## Catalog Correction Notices

No. 2011229E

"DeviceNet Safety DST1 Series Safety I/O Terminals OPERATION MANUAL"

Page 92 "8-2 Examples of Wiring for Each Application" 8-2-2 Two-Hand Input

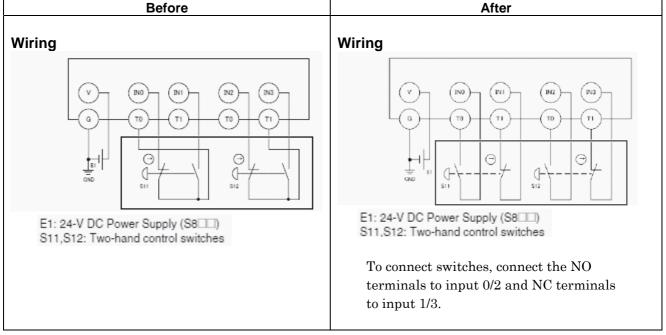
#### [Content of correction]

We revise it at the time of a manual reprint on the next time. (The Revised version will be Rev.06 with the English manual, and Rev. F with the Japanese manual.)
